# HISTORIC AND DESIGN REVIEW COMMISSION

September 07, 2022

**HDRC CASE NO:** 2022-456  
**ADDRESS:** 902 E GRAYSON ST  
**LEGAL DESCRIPTION:** NCB 992 BLK 1 LOT 15  
**ZONING:** R-6, H  
**CITY COUNCIL DIST.:** 2  
**DISTRICT:** Government Hill Historic District  
**APPLICANT:** ERIN OSHAUGHNESSY/OSHAUGHNESSY ERIN E  
**OWNER:** ERIN OSHAUGHNESSY/OSHAUGHNESSY ERIN E  
**TYPE OF WORK:** Construction of a carport, driveway modification  
**APPLICATION RECEIVED:** August 19, 2022  
**60-DAY REVIEW:**  
**CASE MANAGER:** Jessica Anderson

The applicant requests a Certificate of Appropriateness for approval to extend the driveway and install a carport.

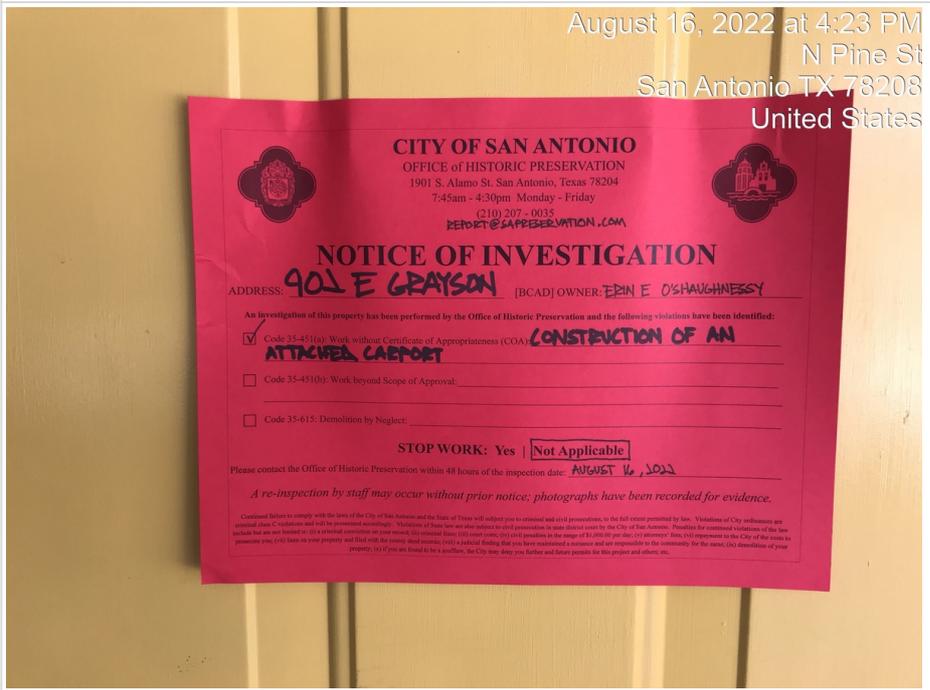
Date	08/16/2022
Time	04:15 PM (-5 GMT)
Context	citizen report
Present Staff	Edward Hall
Present Individuals	None
Types of Work Observed	New Construction
Amount of Work Completed	Completed
Description of work	Construction of an attached carport.

Violation Type	No Certificate of Appropriateness (Code 35-451a)
OHP Action	Posted "Notice of Investigation"
Will post-work application fee apply?	To be determined
